# Access Compliance Report

## Public Rights-of-Way

### (Curb Ramps)

Intersection ID: 31368	Main Street: GREENWAY_VISTA_LN	Cross Street: LINDA_VISTA_LN	Location: W
ADA ID: 46540F780ACE	Ramp Type: BlendTrans1	Initial Pass/Fail: Fail	Overall Compliance: No
		Severity Score: 15

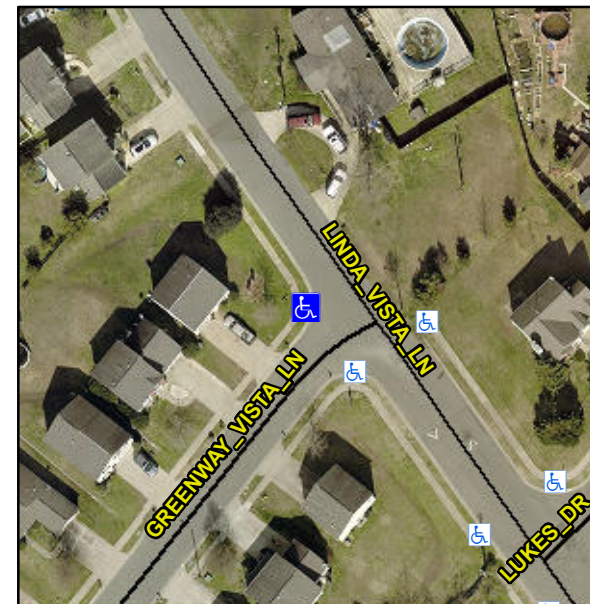
**Not Found, R302.7**

N/A	Ramp inside XWalk1?	N/A	N/A	Ramp inside XWalk2?	N/A
	Road Slope (%)	1.8		Clear Space?	N/A
	Road X Slope (%)	2.0	N/A	Clear Space to XWalk (in)	N/A
N/A	Any Obstructions?	N/A	N/A	Storm Grate/Utility Hazard?	N/A
	Obstruction Type			Storm Grate/Utility Type	
		N/A			N/A
			No	Surface Condition? (G/P)	Poor
			No	Curb Slope (%)	7.3

**Remove & Replace Curb Ramp With Two New Directional Ramps or Equivalent.**
